Safety Evaluation Report

Related to the License Renewal of the Virgil C. Summer Nuclear Station

Docket No. 50-395

October 2003

Figure 1: Wear Degradation of Components in the Extraction Steam System: Theory vs. Actual
Data shown above reflects as-found data populated since power up-rate in 1996.

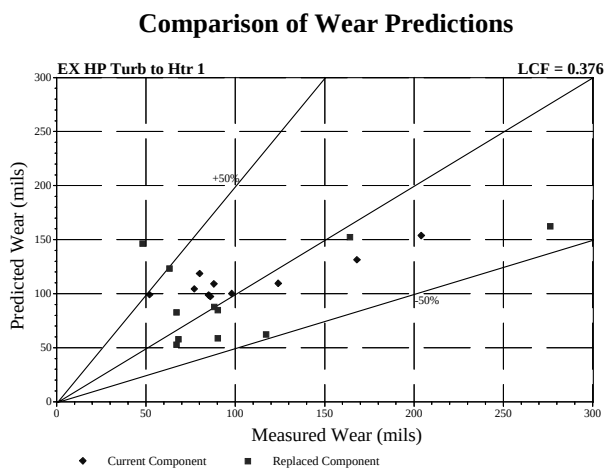
susceptible to FAC. The staff also requested a sample list of components susceptible to FAC with each component's initial, current, and future predicted wall thicknesses, to demonstrate the effectiveness of the Flow-Accelerated Corrosion Monitoring Program. In its response dated June 12, 2003, the applicant stated that the Flow-Accelerated Corrosion Monitoring Program will detect loss of material due to FAC prior to the loss of component intended function. The applicant referenced the October 1992 NRC Inspection Report 50-395/92-20, which stated, "The licensee has established an effective program to maintain high energy carbon steel piping systems within acceptable wall thickness limits." The staff finds that while the referenced inspection report affords some assurance of the effectiveness of the Flow-Accelerated Corrosion Monitoring Program, the report did not supply the information sought by the staff. Therefore, the staff requested a list of those systems, within the program scope, and the components most susceptible to FAC, in addition to the initial, current, and future predicted wall thicknesses, to demonstrate the effectiveness of the Flow-Accelerated Corrosion Monitoring Program.

In subsequent correspondence dated September 2, 2003, the applicant discussed the integration of prediction and inspection inherent in its FAC program. The applicant stated the system most susceptible to FAC at VCSNS is the extraction steam system. This conclusion has been confirmed by the applicant's predictive model and the as-found ultrasonic data for many components. The predictive model of record (CHECWORKS™) represents an analysis tool used by the applicant in the selection of problem areas. This model also aids in the inspection scheduling process. Over time, the applicant determined that model predictions with as-found ultrasonic data have returned reasonable agreement. The applicant provided an example of the predicted vs. measured wear comparisons for components in the extraction steam system summarized below.

The applicant stated that based on the predictive model, deviations on wear plots should be within ± 50 percent. The above plot shows a fairly well-calibrated extraction steam analysis line. The line correction factor (LCF) of 0.376 indicates that the model is slightly, yet conservatively, over-predicting wear. As can be seen from the plot above, the applicant observed generally good agreement between predicted and measured wear. The applicant
